SUBJECT: Site Plan Review for Hudson Crossing Parkway – Spec industrial building at Parcel #3009750

PC Case No: 2016-19

RE: PC 2016-19-Site Plan Review for Hudson Crossing – 125,000 square foot spec building

Date: July 7, 2016
To: Greg Hannan, City Planner, Community Development
From: Thomas J. Sheridan, P.E., P.S., City Engineer
Re: **Hudson Crossing Site Plan Review**

ARCHITECTURAL SITE PLAN
 SCALE 1" = 40'
 0 40

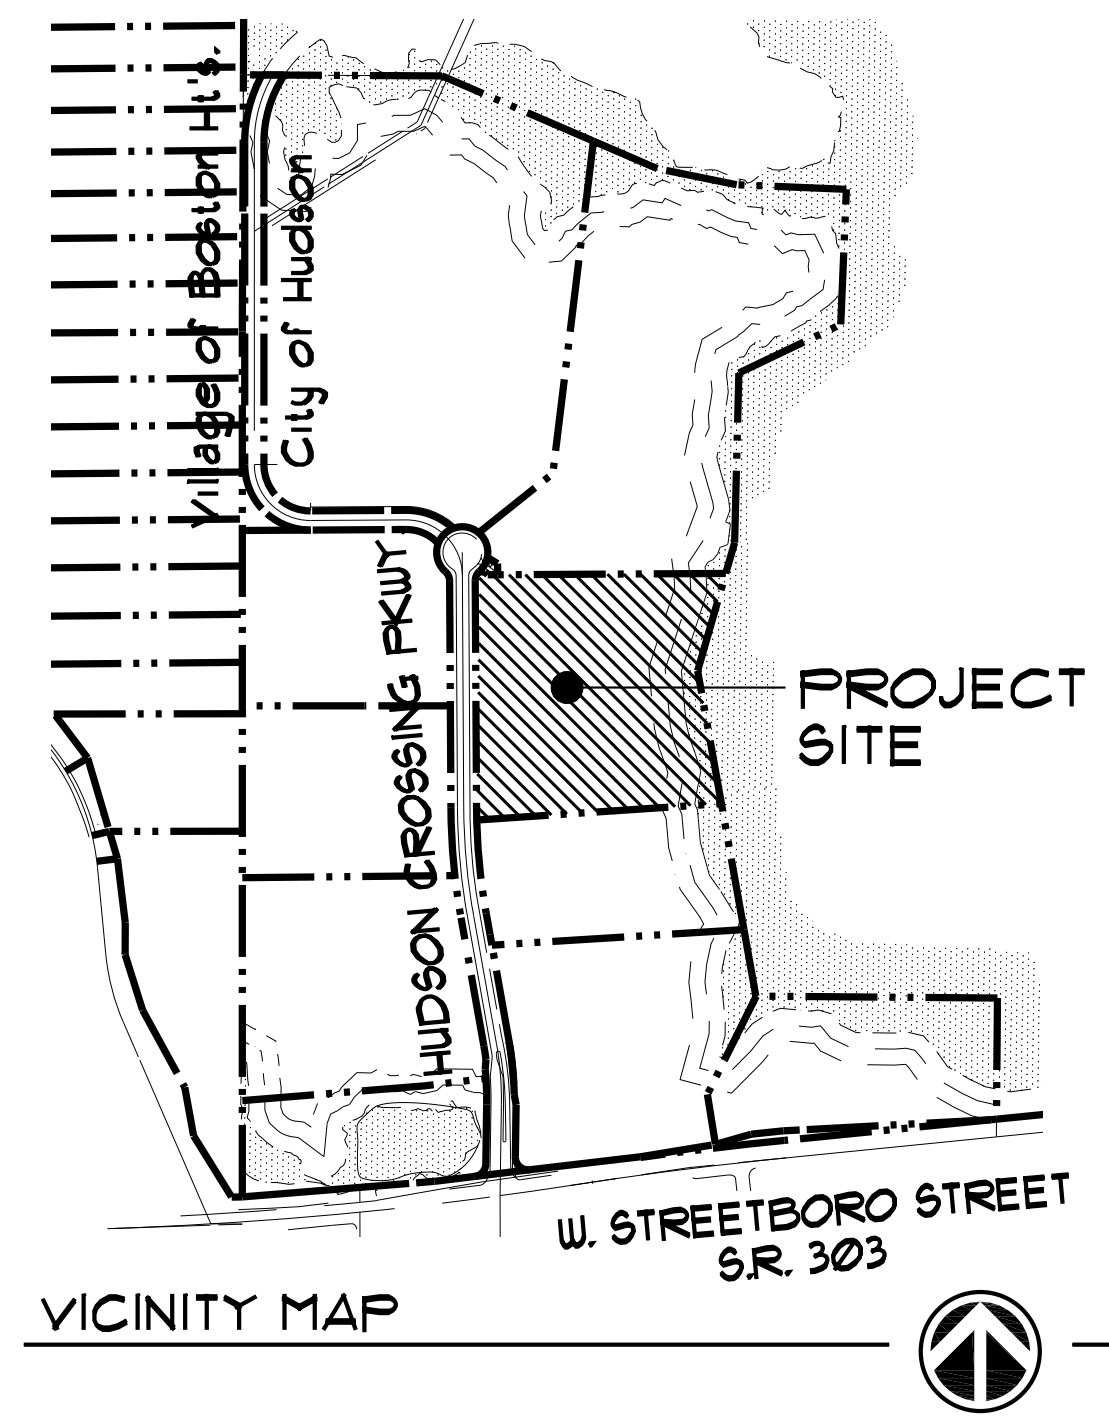
Sidewalks are required abutting a public street, along the building façade featuring a customer entrance, and along a building façade abutting a parking area. The widened sidewalk installed to the south of the development area should be installed along the applicable frontage of the development. Sidewalks should also be extended along the full frontage of the building façade as it contains the public entrance and abuts parking areas.

Landscaping: The concept site plan indicates appropriate areas to accommodate the necessary front yard, street trees, perimeter parking lot, and interior island landscaping. A final landscaping plan will need to be submitted and accepted prior to authorization to proceed.

Parking and Exterior Lighting: Industrial/manufacturing facilities are required to provide one space for each employee on the shift with the highest number of employees. The applicant has noted an anticipated parking demand at full occupancy of 164 spaces. The current proposal appropriately contains 100 paved spaces with an additional 120 landbanked parking spaces. Tenant specific parking needs will be assessed as use certificates are submitted for proposed tenants. An exterior lighting plan including photometrics must be submitted in compliance with applicable standards of Section 1207.18(g).

1. An administrative lot split application must be approved by the City of Hudson for the proposed lot split.
2. Incorporate a widened sidewalk along the frontage of the development. Sidewalks must also be extended along the full frontage of the front building façade.

3. A final landscaping plan must be submitted and accepted to comply with applicable front yard, street tree, perimeter parking lot, and interior island landscaping requirements.

4. An exterior lighting plan including photometrics must be submitted in compliance with applicable standards of Section 1207.18(g).
5. The comments of City Engineer Thom Sheridan must be addressed per the July 7, 2016 correspondence.

WEST ELEVATION
SCALE: 1/16" = 1'-0"

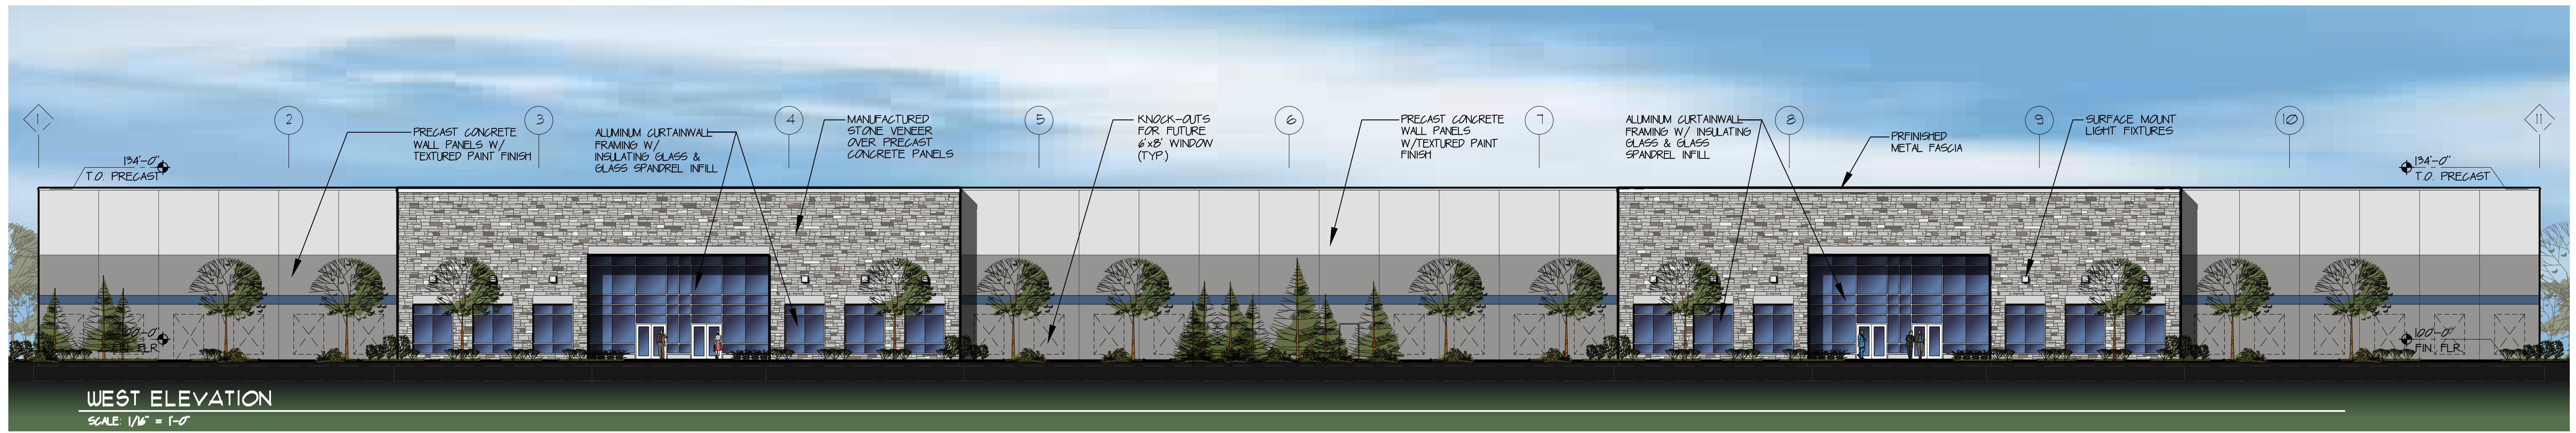
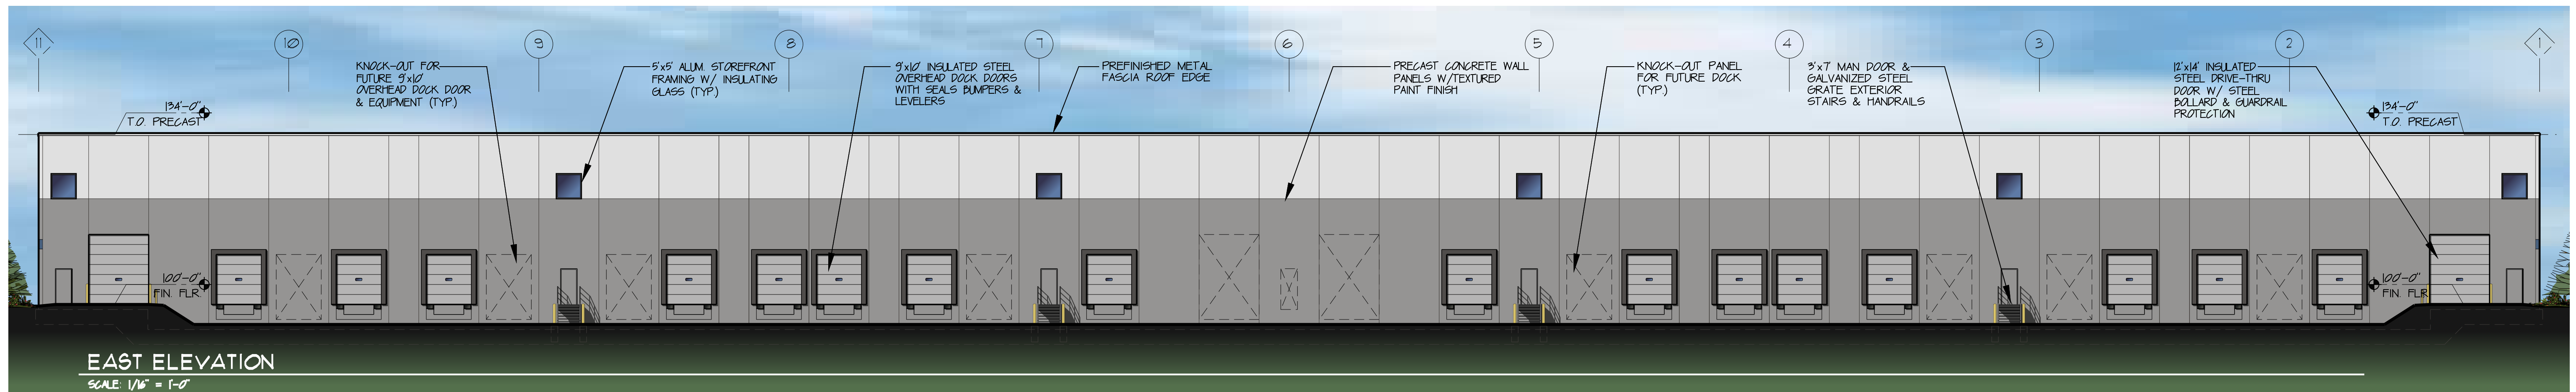
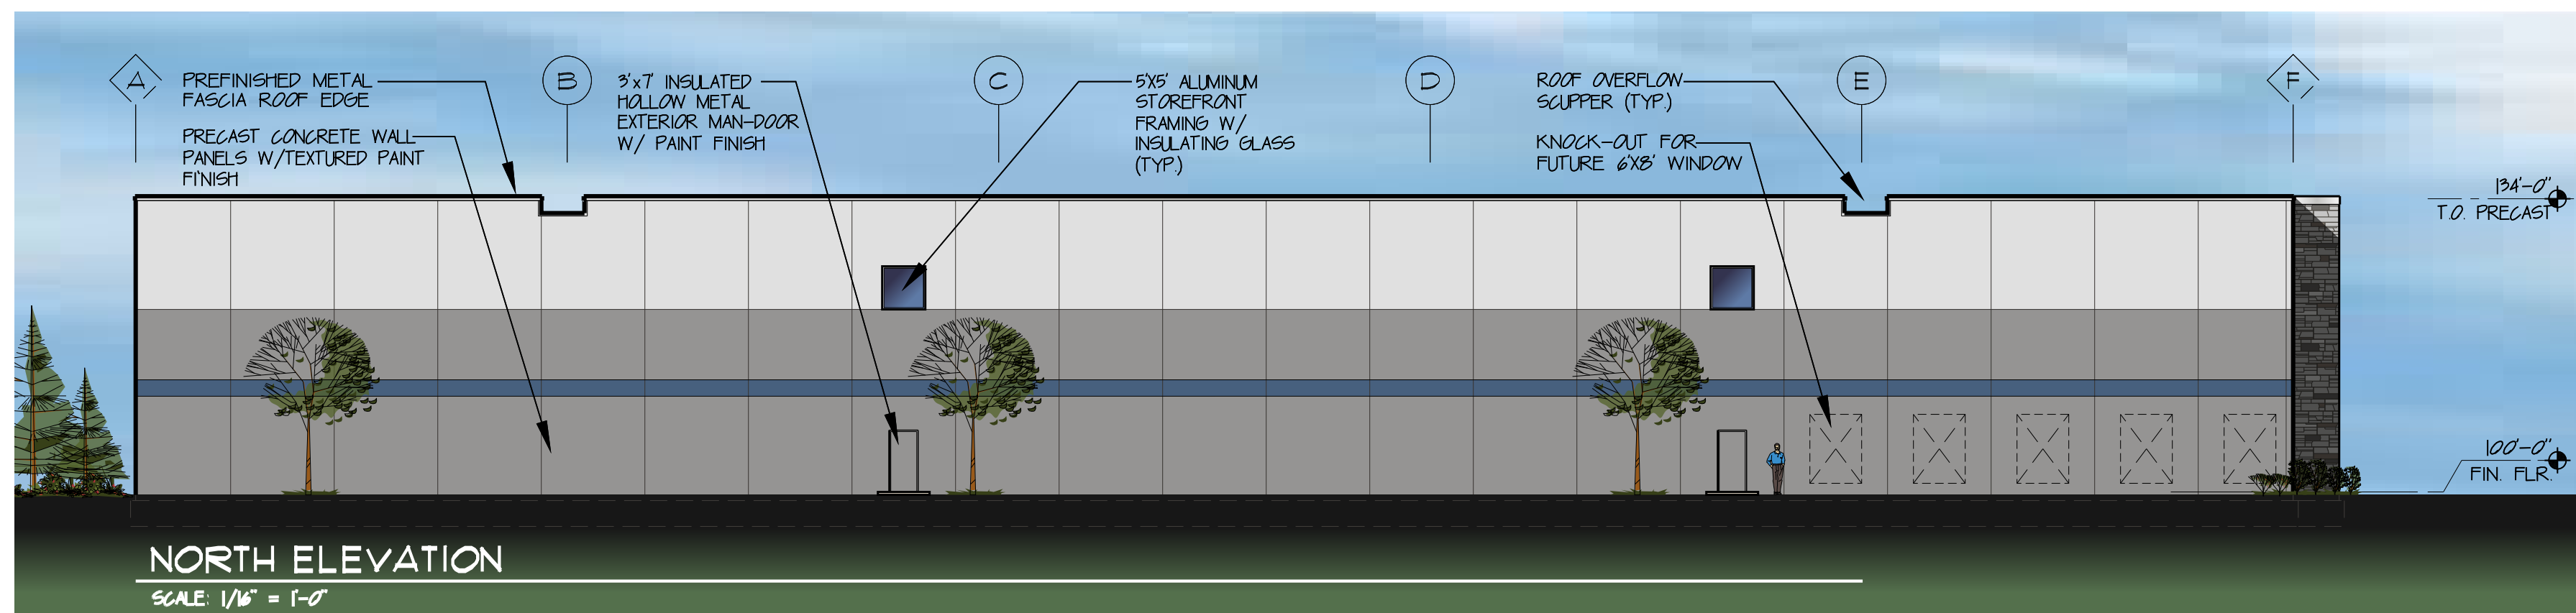
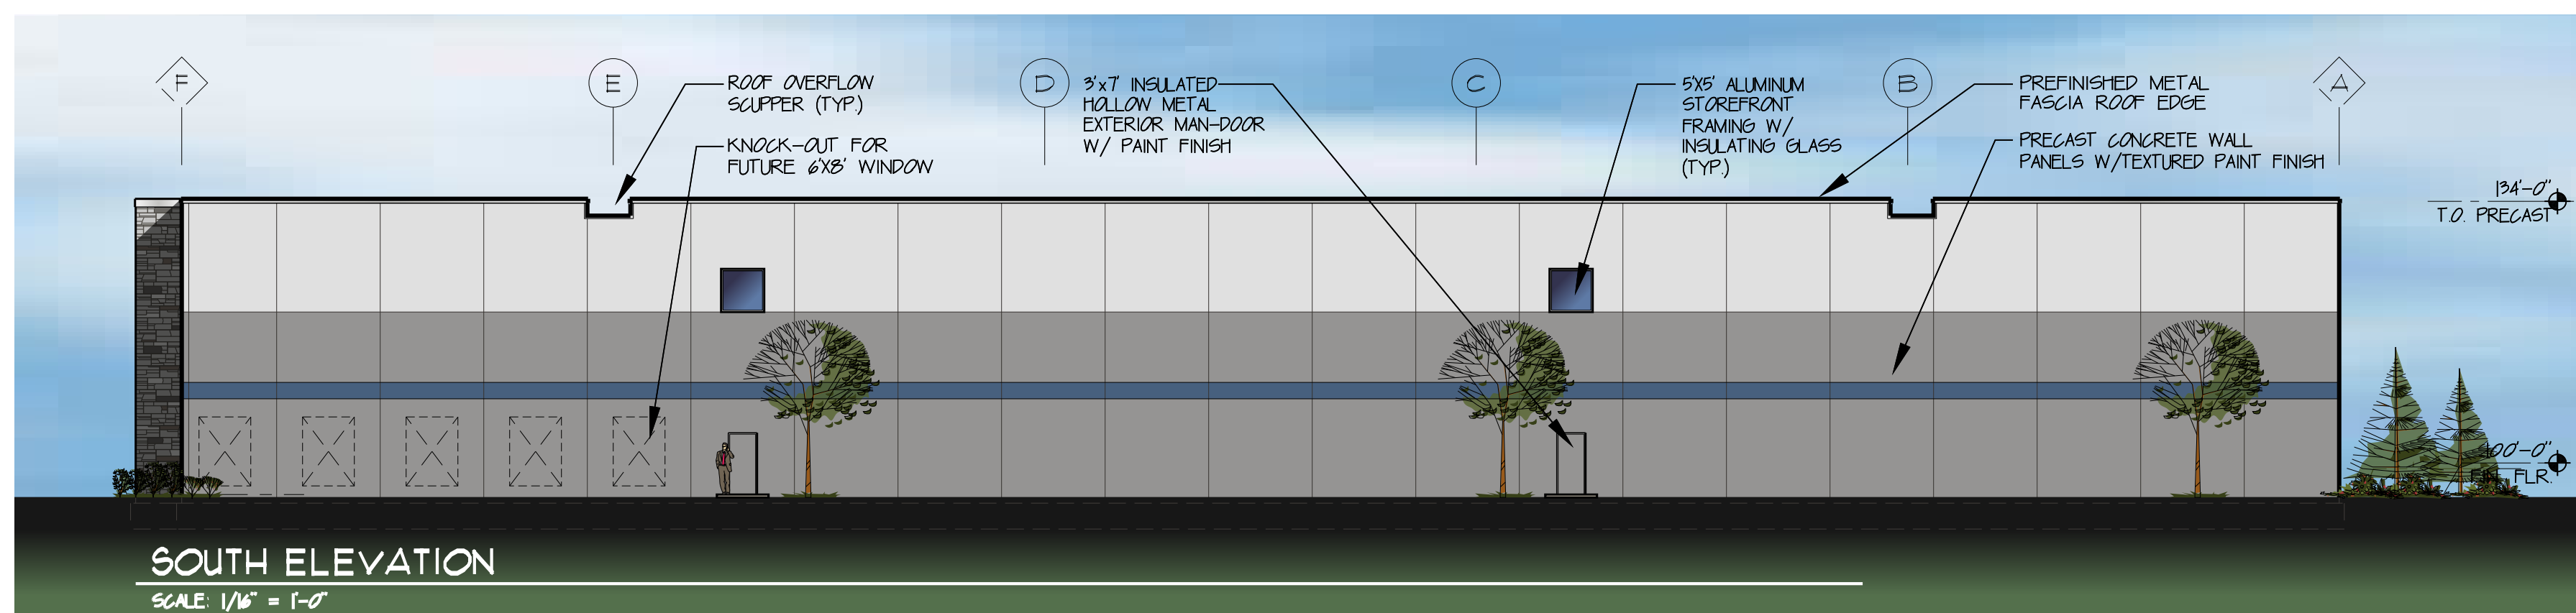
Industrial Design: Application for building design approval was submitted with the application for site plan approval. Staff notes the building design contains a precast wall panel system with two forward projecting entry masses containing stone veneer, large glass panels, and accent

lighting. Landscaping is also proposed along the front façade of the building. The proposed loading docks have been sited at the rear elevation. The design subcommittee has reviewed the proposed submittal and recommends Planning Commission acceptance of the design at the July 11, 2016 meeting.

6. Planning Commission accepts the recommendation of the Design Subcommittee for Development in Districts 6 and 8 and approves the project design.
7. The applicant shall install silt fencing and/or polypropylene fencing to mark and protect the approved clearing limits, which shall be maintained by the applicant.

GRADING PLAN

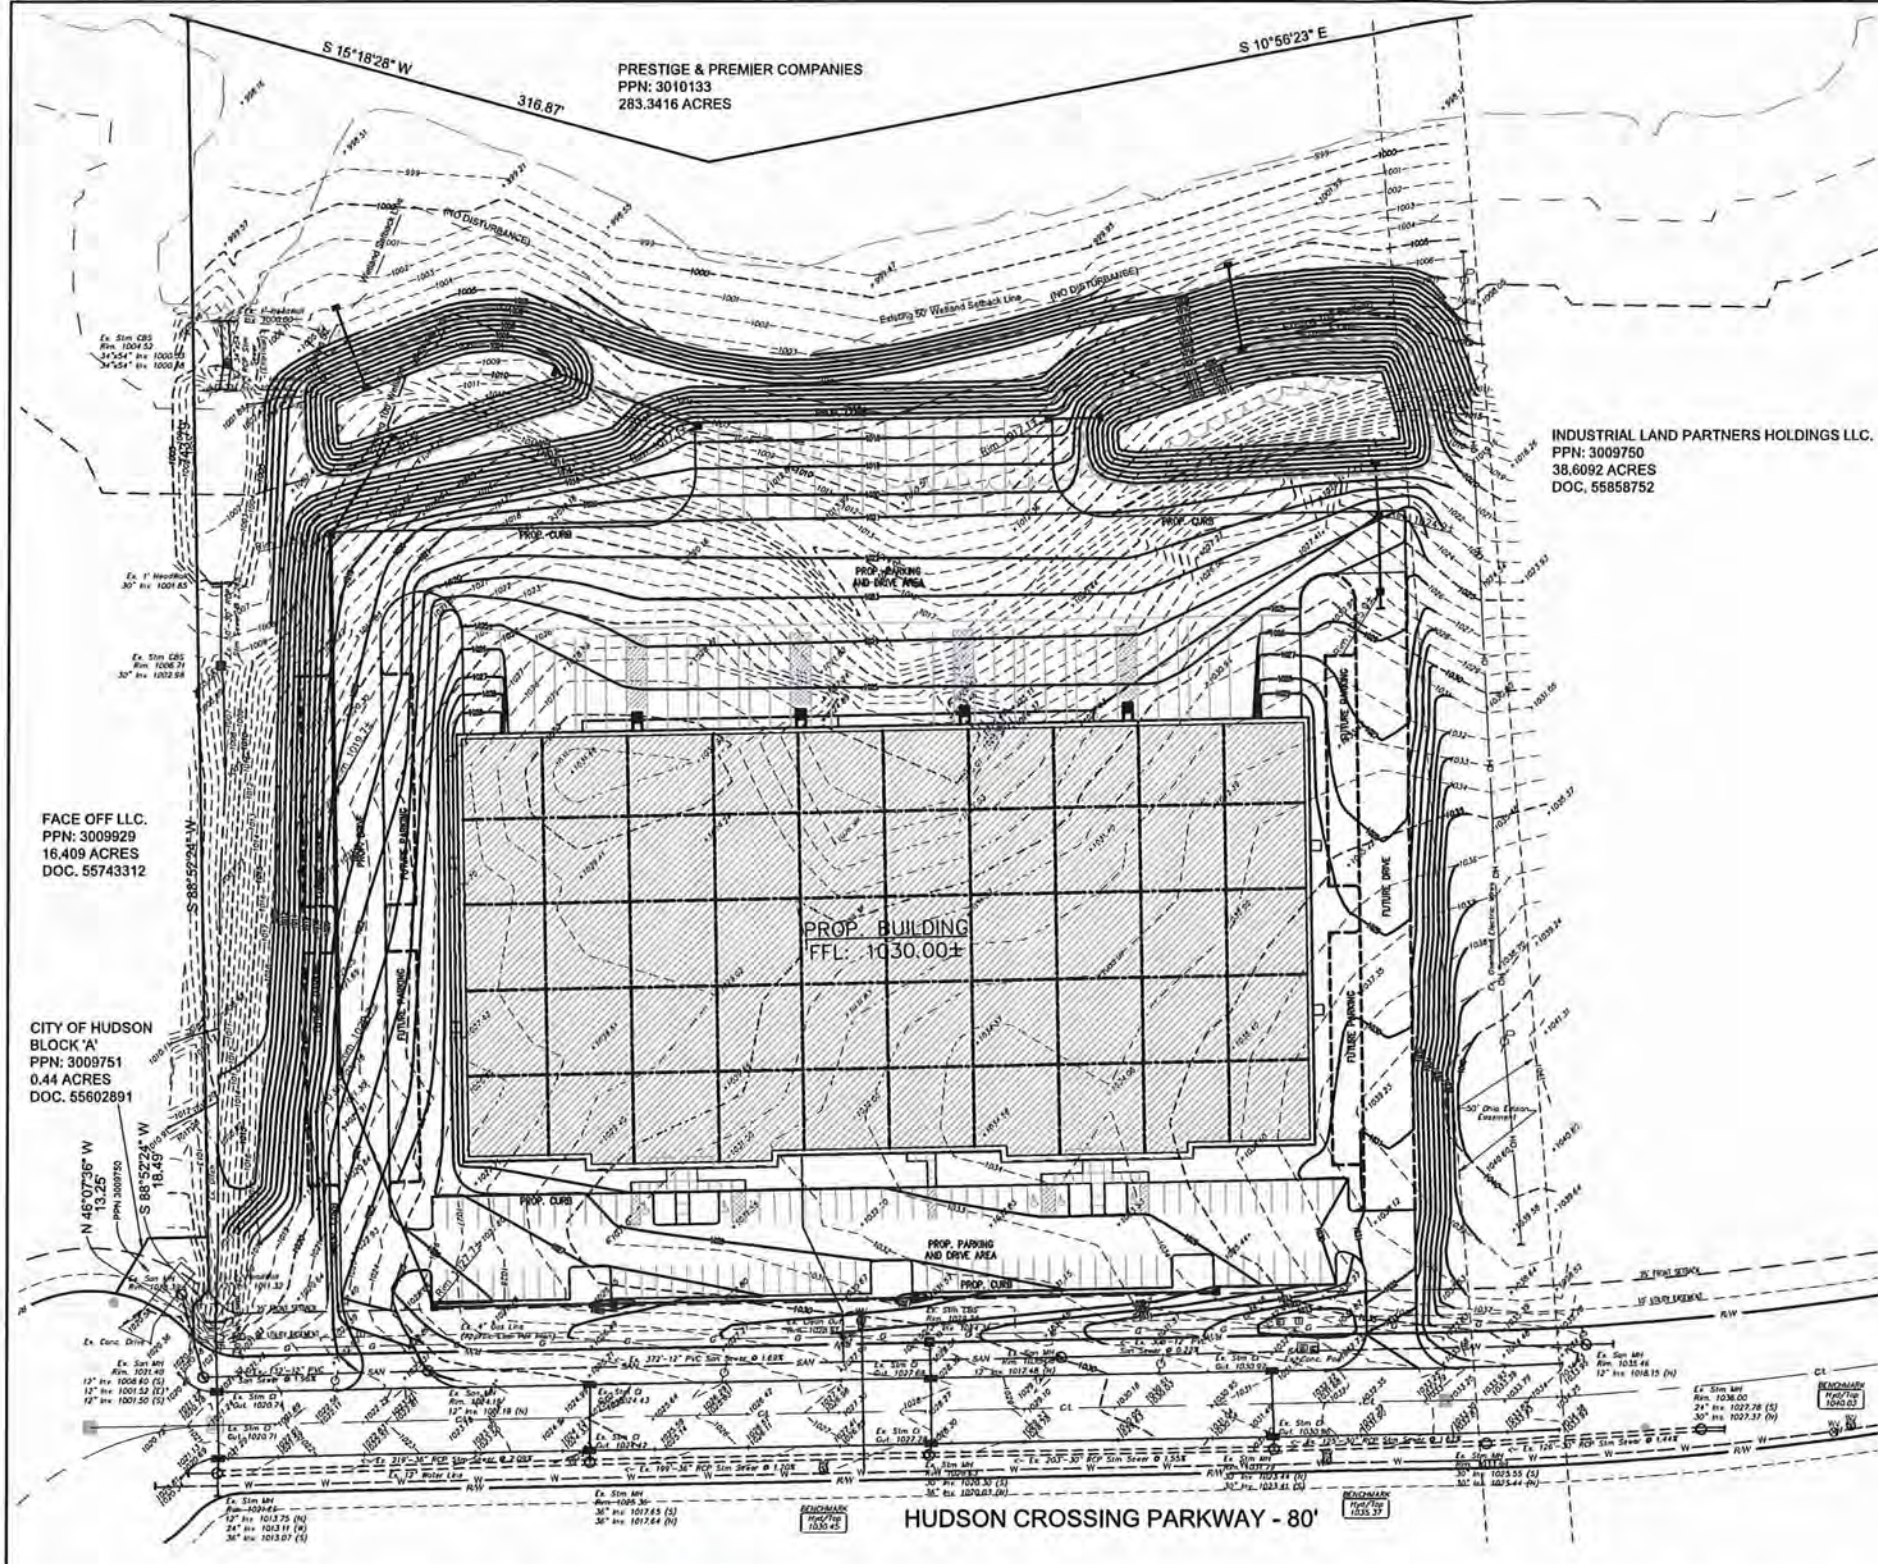
1. Site survey of the property including existing two foot contours.
2. Anticipated utility layout.
3. Preliminary grading design at one foot contour
4. Submittal of administrative lot split application
